Revision 1 June 2021

Dealer Service Instructions for:

# Safety Recall Y36 / NHTSA 21V-398 Wheel Studs

2012 - 2021 (D2) Ram 3500 Pickup

Figure 1A - Owner's Manual Page

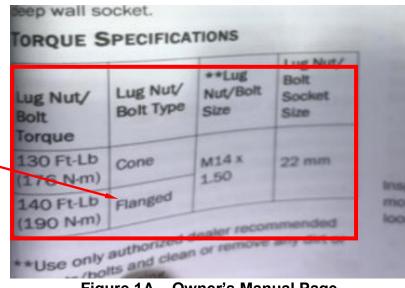
ADHERE THE NEW
INFORMATION LABEL TO THIS
SECTION
PAY SPECIAL ATTENTION TO
COVERING THE FLANGED
LUG NUT TORQUE 140 FT-LB /
190 N-m.

Lug Nut/Bolt Torque Lug Nut/Bolt Type		Lug Nut/Bolt Size Lug Nut/Bolt Socket Size		
130 Ft-Lb (176 N·m)	Cone	M14 x 1.50	22 mm	
129 Ft-Lb (175 N·m)	Flanged	M14 x 1.50

Figure 2A - User's Guide

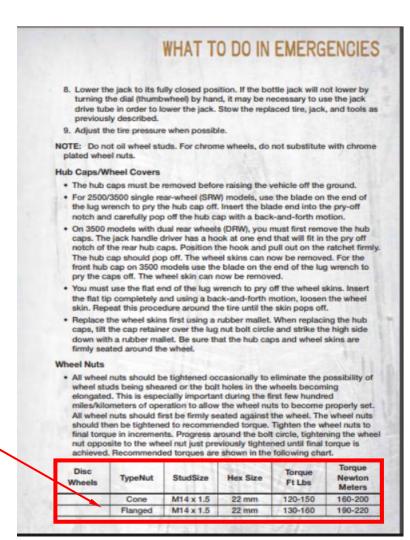
ADHERE THE NEW INFORMATION LABEL TO THIS SECTION PAY SPECIAL ATTENTION TO COVERING THE FLANGED LUG NUT TORQUE 140 FT-LB / 190 N-m.

Lug Nut/Bolt Torque	Lug Nut/Boit Type	Lug Nut/Bolt Size	Lug Nut/Bolt Socket Size	
130 Ft-Lb (176 N·m)	Cone	M14 x 1.50	22 mm	
129 Ft-Lb (175 N·m)	Flanged	M14 x 1.50	22
